SITE DEVELOPMENT PLAN  
**MONUMENT STEEL STRUCTURES**  
 SITE LANDSCAPE PLAN  
 18910 BASE CAMP ROAD  
 MONUMENT, COLORADO

SHEET NUMBER
<b>L1</b>

# Landscaping\_v3-redline.pdf Markup Summary

### SITE LANDSCAPE PLAN

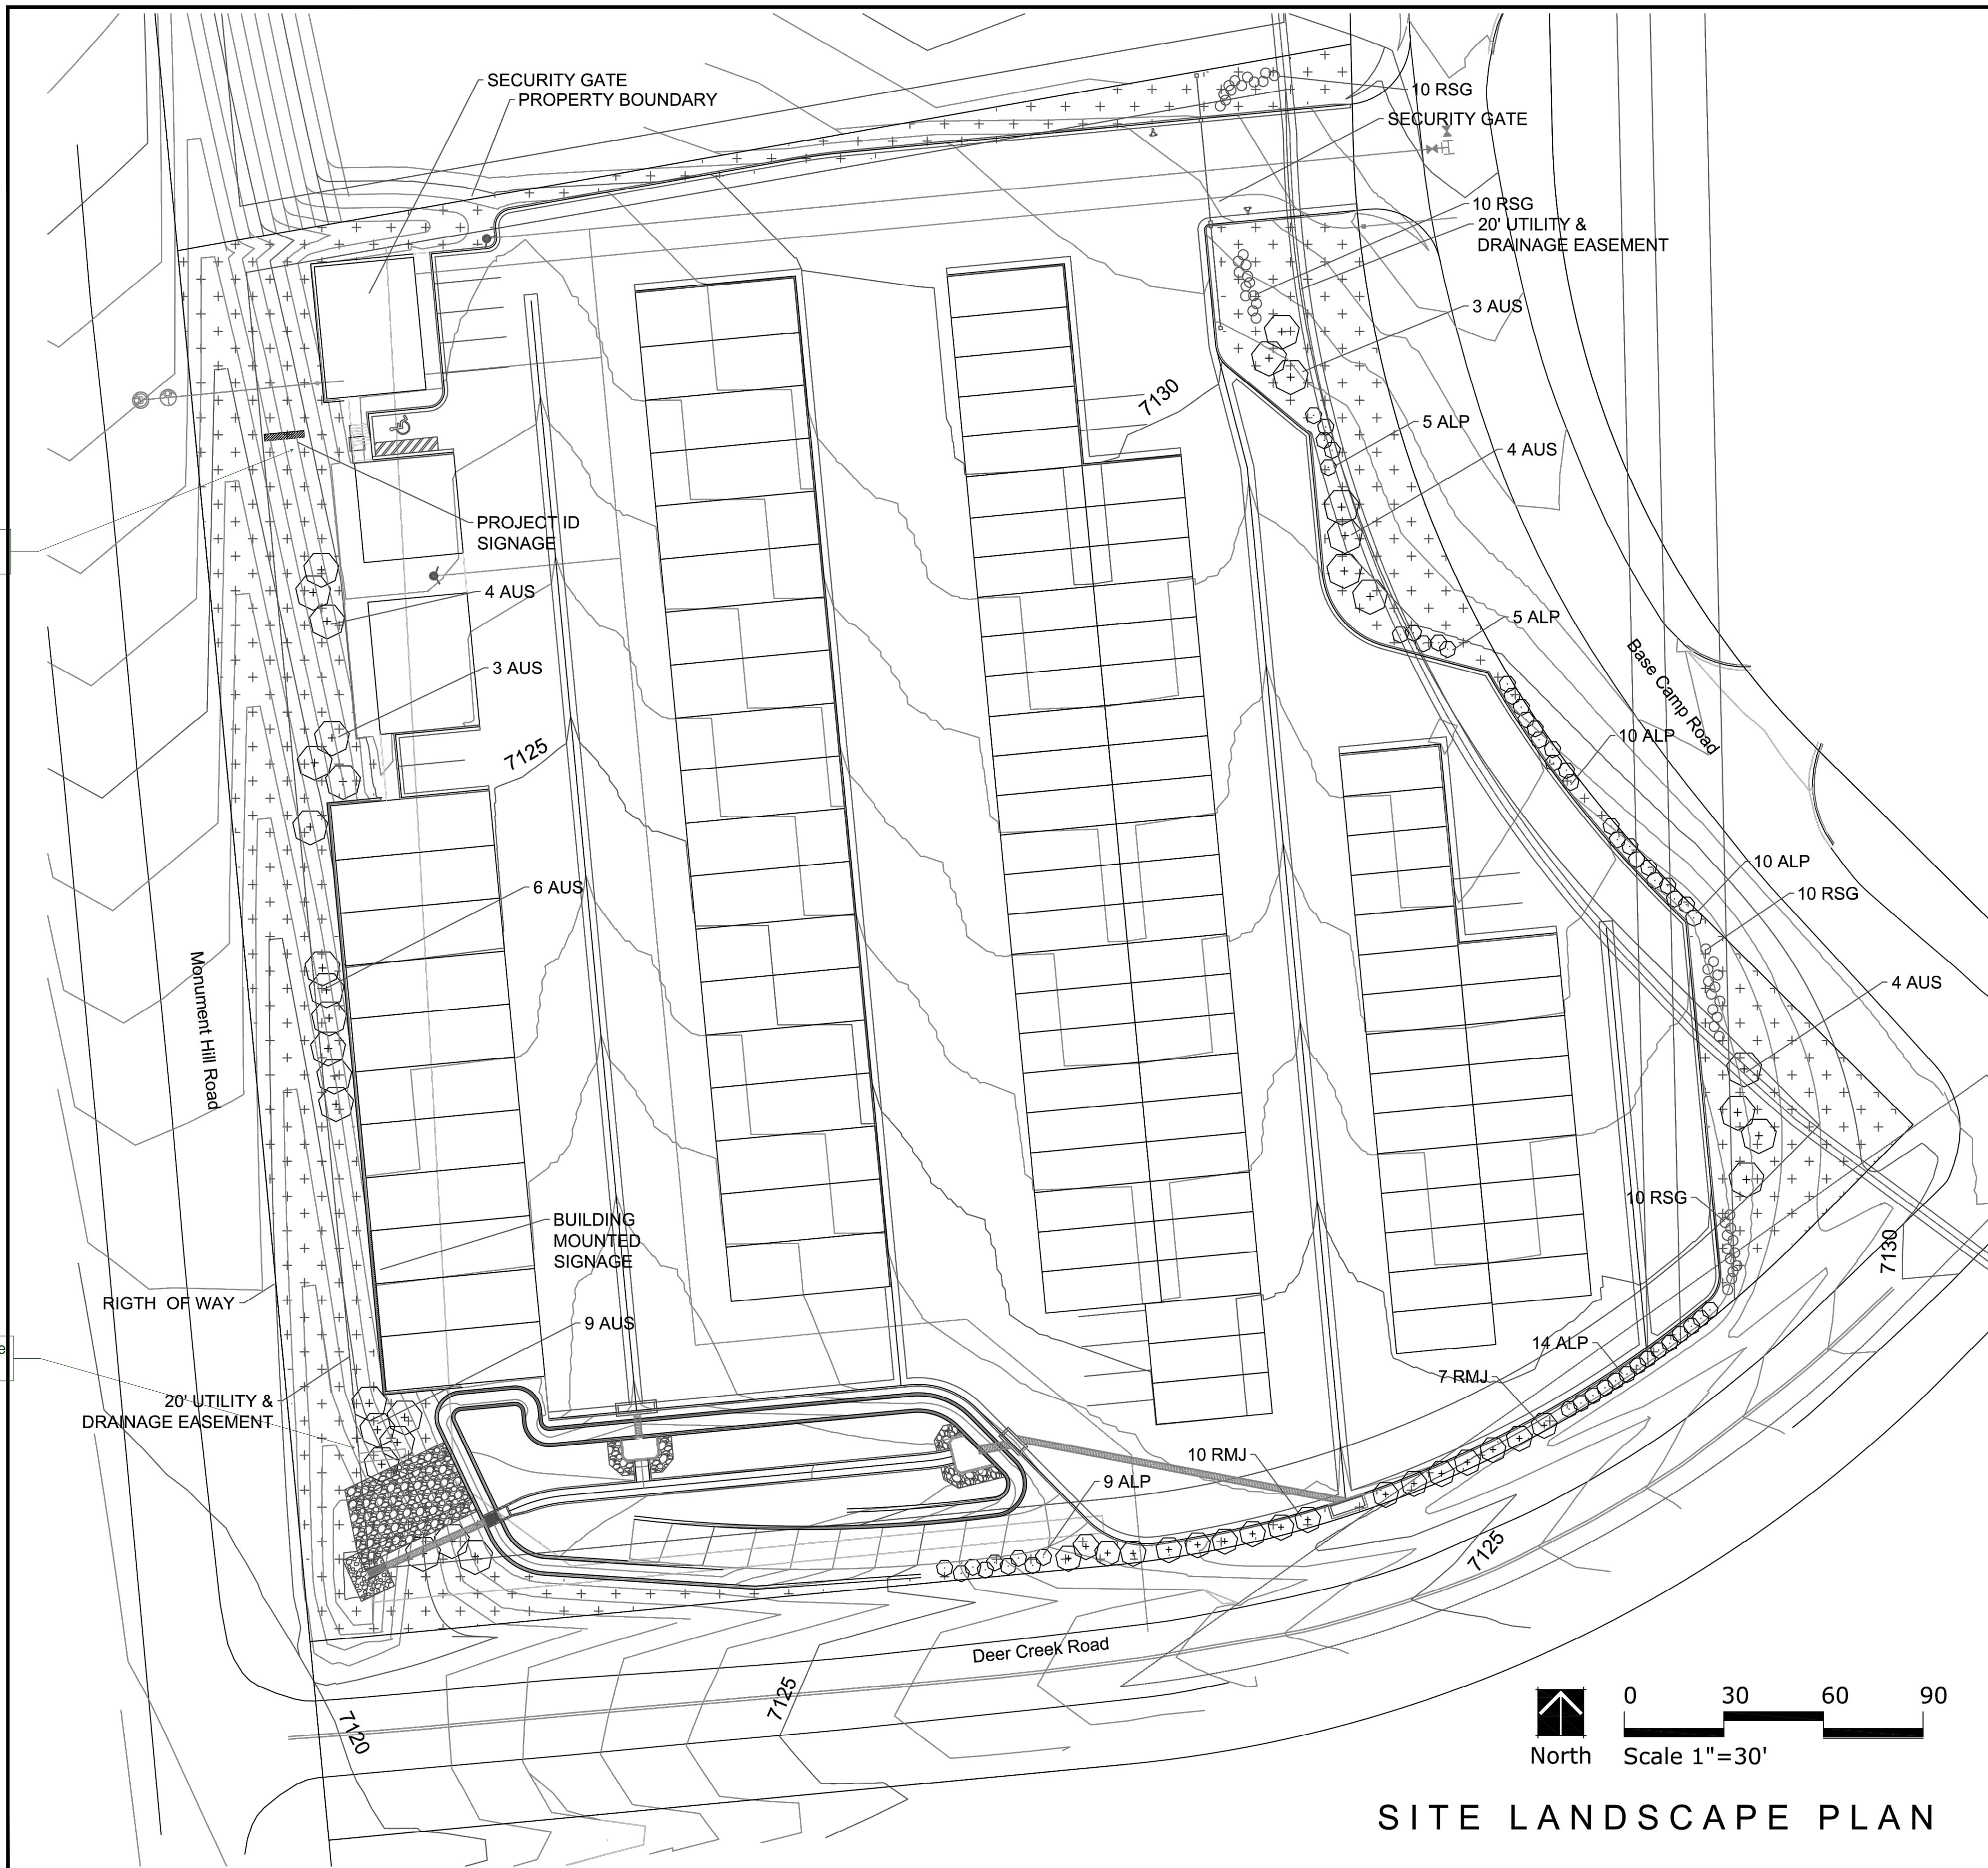
Where is the sign going?

Signage was put here on the sign plan.
